MEMORANDUM

SUBJECT: SP21-064; Douglas 234 F6 L2 - Car Wash
Review Comments 01

CARWASH SITE PLAN

LOT 2 OF DOUGLAS 234 FILING NO. 6

1 LANDSCAPE PLAN

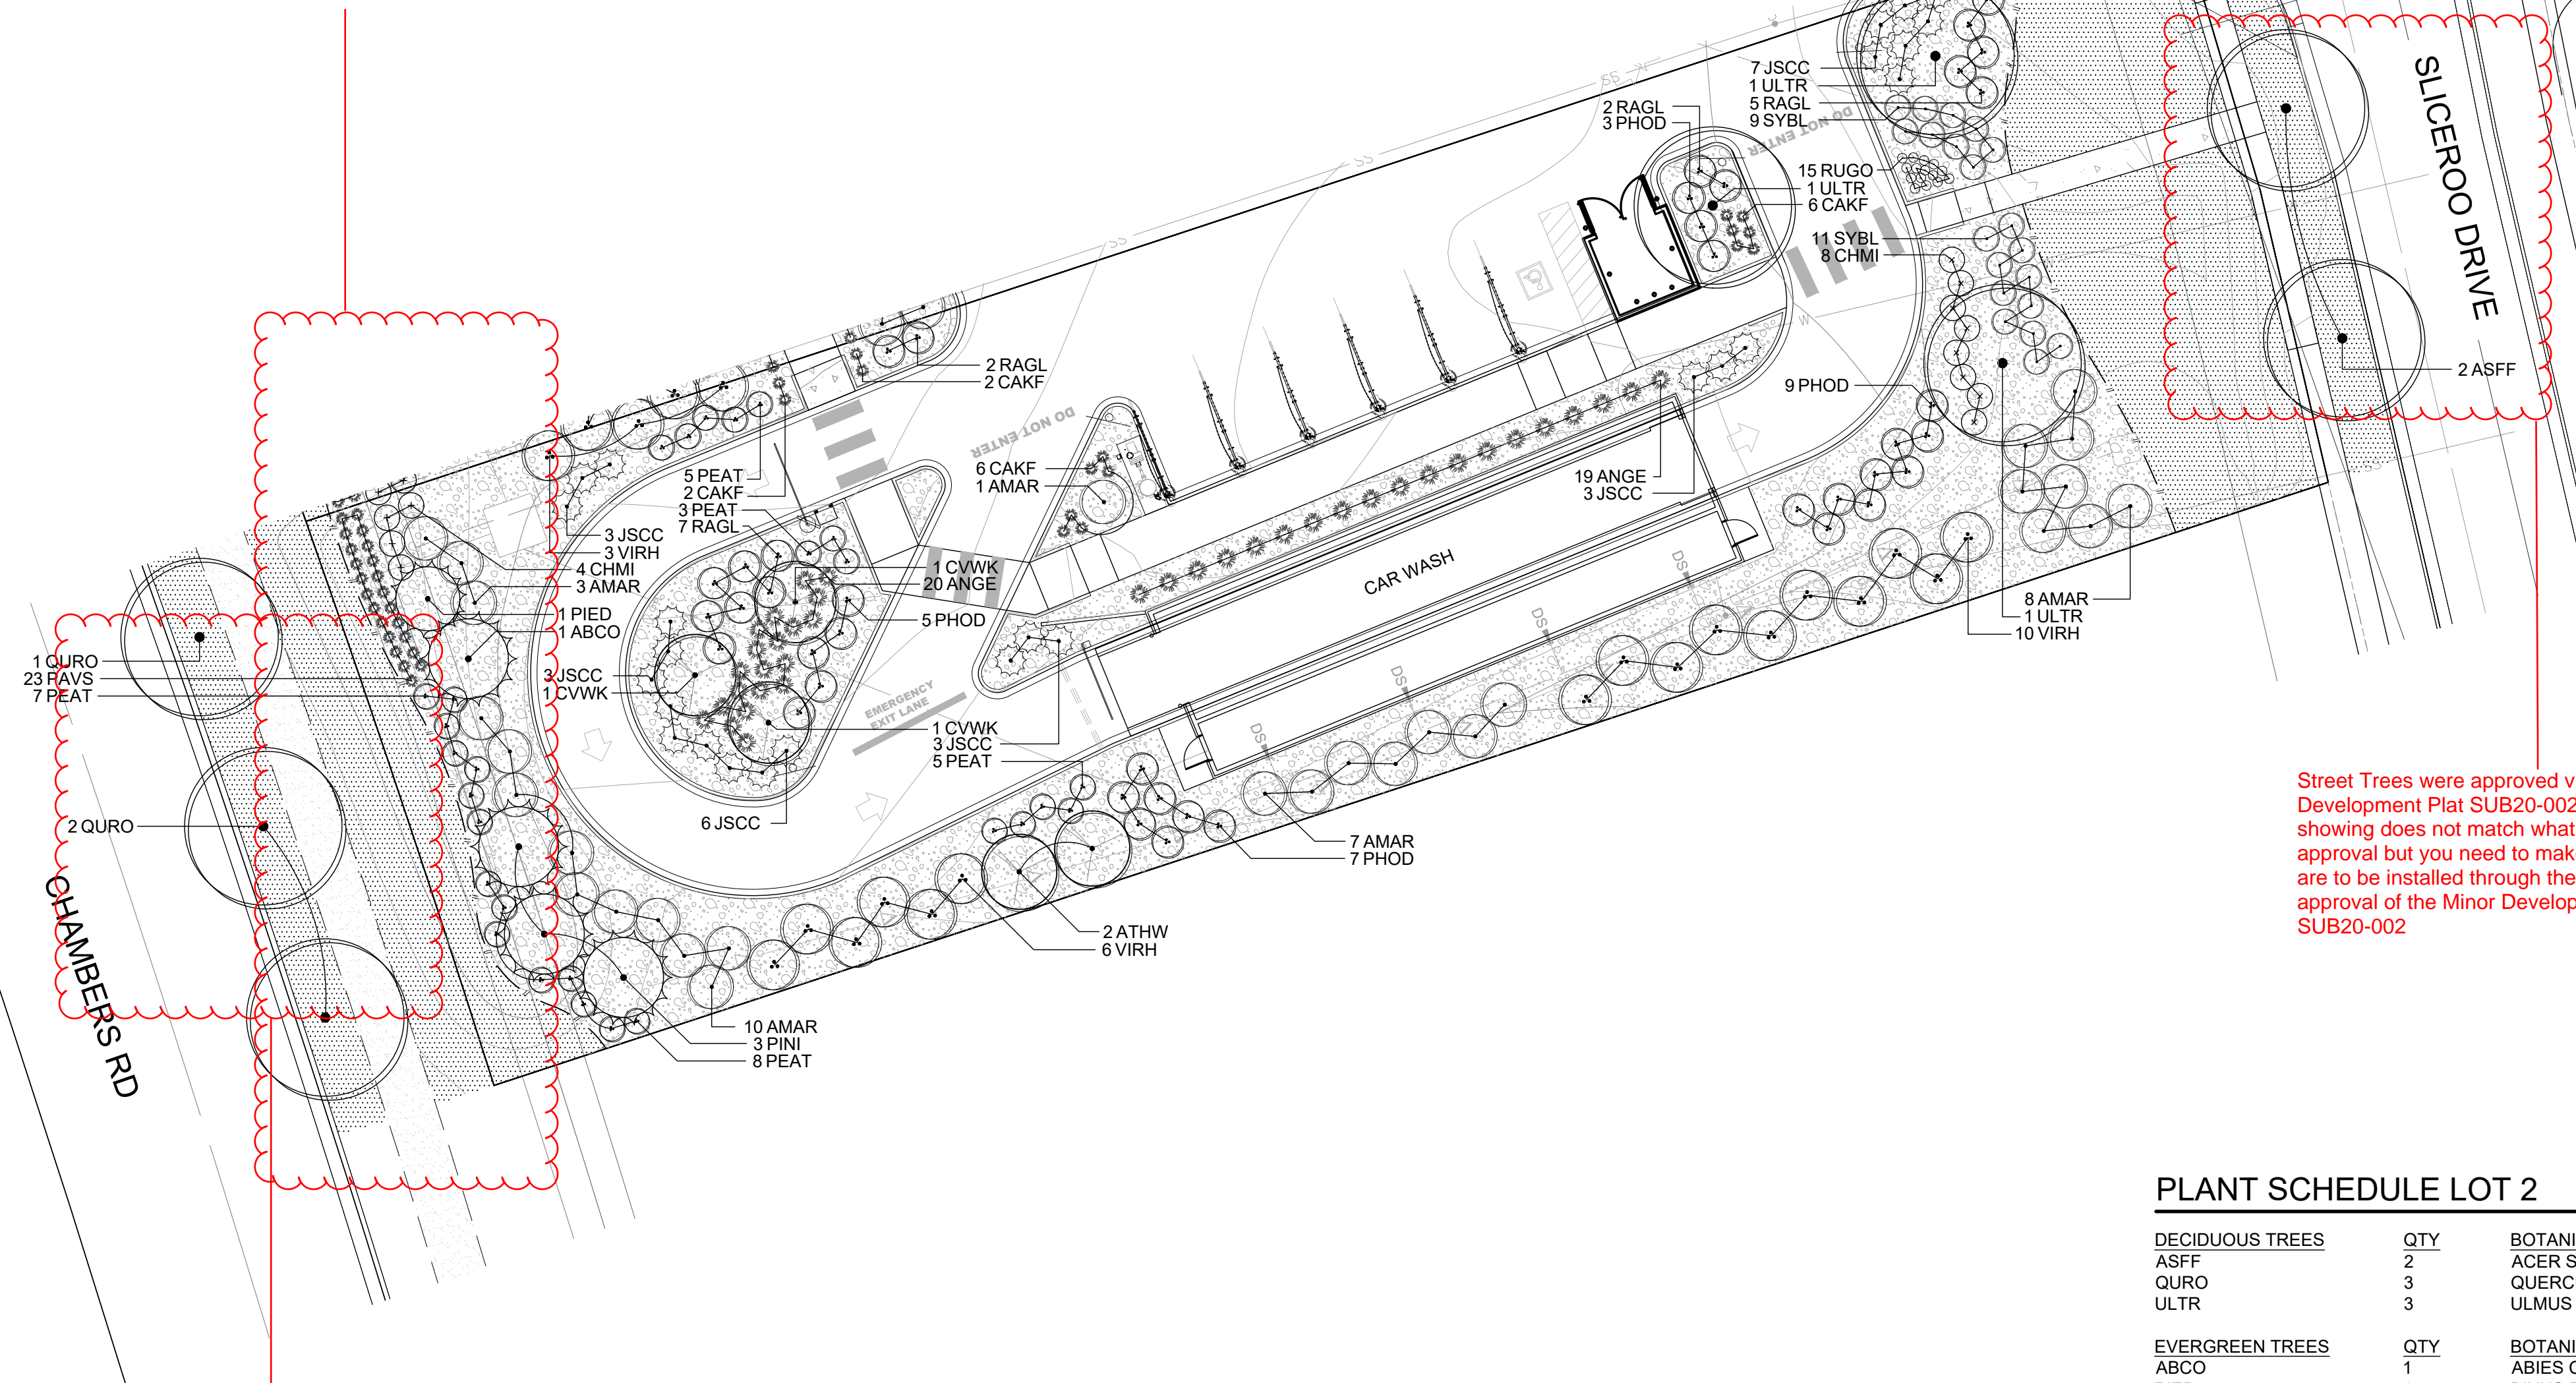
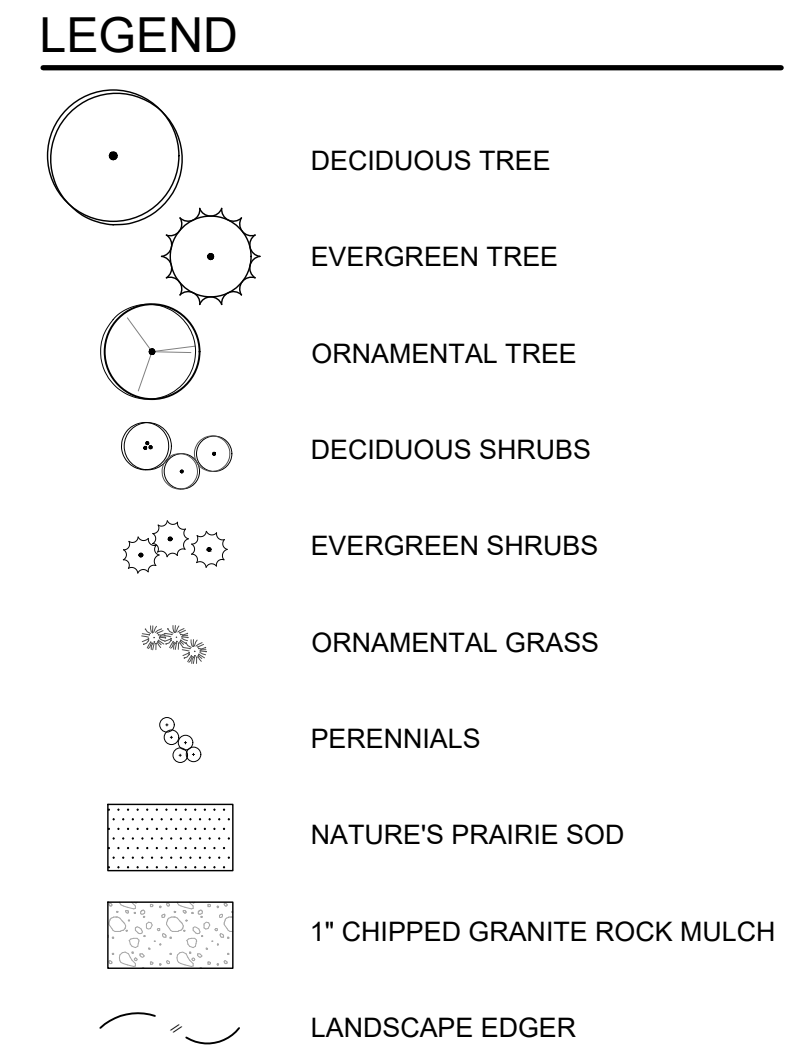
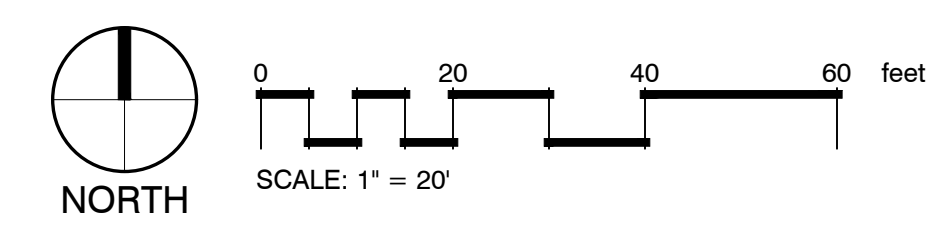
The Enhanced Landscape Perimeter ratios should be used (tree requirement: 1/40 L.F. and shrubs: 5/40 L.F.) along all rights-of-way: Red Sky Dr., Chambers road, and Sliceroo Dr.

Street Trees were approved via Minor Development Plat SUB20-002. What you are showing does not match what was approved in that approval but you need to make a note that these are to be installed through the Agreement and approval of the Minor Development Plat SUB20-002

Include Maturation Heights

Street Trees were approved via Minor Development Plat SUB20-002. What you are showing does not match what was approved in that approval but you need to make a note that these are to be installed through the Agreement and approval of the Minor Development Plat SUB20-002

Traditional turf grasses shall only make up fifteen percent (15%) of any required on-site landscaping for commercial and industrial uses. You need to show the Percentage and compliance.

1. Call out lot size to show how you get 15%
2. Break out the required Streetscape Landscaping-no further that 1 tree ever 40' apart
3. Need to break out Parking Lot Perimeter Landscaping
4. See example chart provided on referral notes.
5. Math needs to be shown for all calcs. of how you get to the required percentages
